DRAWING NO. 35-002A
 BRIDGE SHEET 2A OF 21

SHEET DETAILS:
FRAMING PLAN - MOD I & BT-63 BEAMS

CONTR./PROJ. No. SPT00-7073-00(001) CONTRACTOR: ROGERS BRIDGE

COUNTY, STATE & PROJECT DETAILS:
 WILLIAM FEW PARKWAY OVER UCHEE CREEK COLUMBIA CO., GEORGIA

FRAMING PLAN

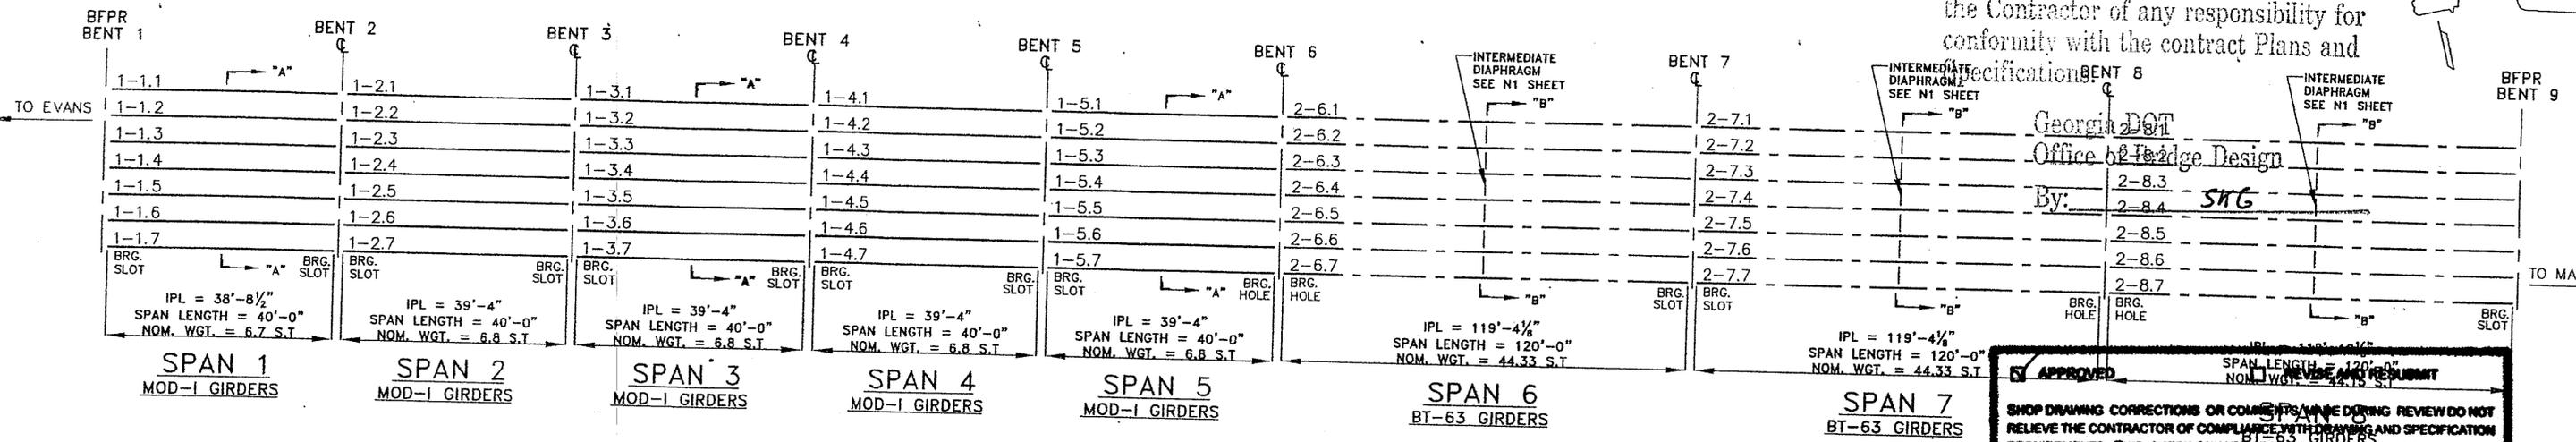
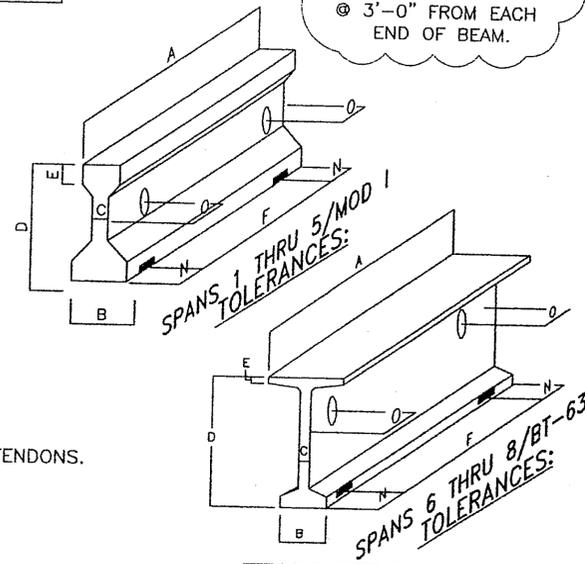
Approved in general. Details not checked. This approval shall not relieve the Contractor of any responsibility for conformity with the contract Plans and Specification.

APPROVED
